August 22, 2024

**Re: Notification of Data Availability and Request for Comment:
*Energy Conservation Program: Energy Conservation Standards for
Consumer Water Heaters, EERE-2017-BT-STD-0019, RIN 1904-AF65,
89 Fed. Reg. 59692 (July 23, 2024)***

Venting Design as Described in DOE’s TSD: Misalignment with Horizontal Installations (Figure 8D.3.3)

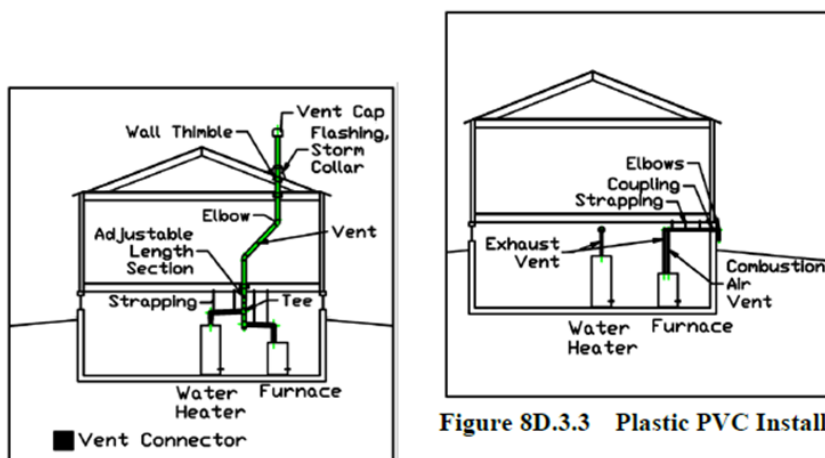
The DOE model identifies 86% of all GIWH installations in the 10,000 trials as horizontal, with the remaining 14% utilizing vertical vent designs like those used by non-condensing furnaces, typically spanning 10 to 20+ feet. However, the model likely overestimates the percentage of vertical installations for both new and replacement GIWH installations. The economic advantages of new non-condensing GIWH systems typically favor horizontal venting over the more complex and costly vertical Category I venting systems used by other water heaters. Fixing the overestimation of new GIWHs installed with vertical venting, especially long 20+ foot length installs, would reduce average Life Cycle Cost (“LCC”) savings further.

Despite recognizing that 86% of installations are horizontal, the DOE model inaccurately applies the same labor and material costs to these installations as it does to vertical installations. This results in an overestimation of costs for horizontal installations, which are generally much simpler than vertical installations. The average horizontal system requires less than 7 feet of venting and follows a straightforward work plan, like that of a condensing unit. Such installations typically involve connecting just 3 or 4 individual parts through a wall, drastically simplifying the process compared to the more complex Category I vented storage water heaters or non-condensing furnaces.

The model assigns Efficiency Level 0 (“EL0”) to 30% of trials—of which about 10% involve vertical venting in the base case. For the horizontal EL0 GIWH installations, the model assumes the same labor and part requirements for vertical installations, failing to reflect the simplicity and lower cost of horizontal venting designs in general.
